TECHNICAL BULLETIN

Document: TB_T318_004

Subject: Front suspension bracket

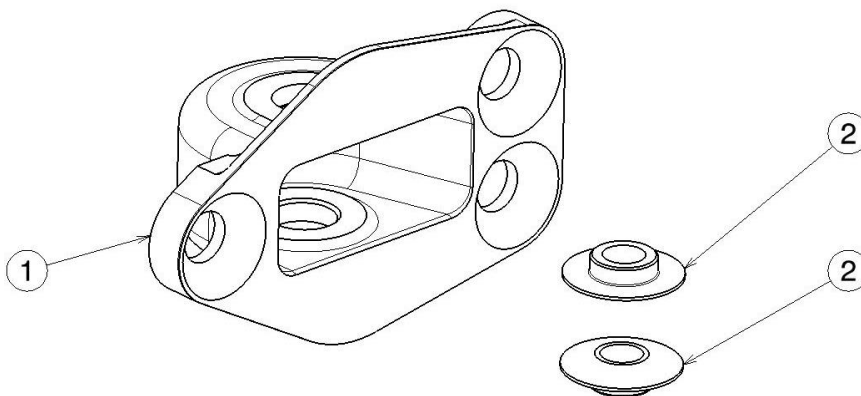
Tatuus is providing a replacement for the front bottom suspension brackets 24 10 031. The new item engraved with pn. 24 10 043 (or 24 10 044) must replace the existing pn. 24 10 016.

We remind you that the tightening torque of the fixing bolts (UNI5933-M8x20) must be set at 35Nm:
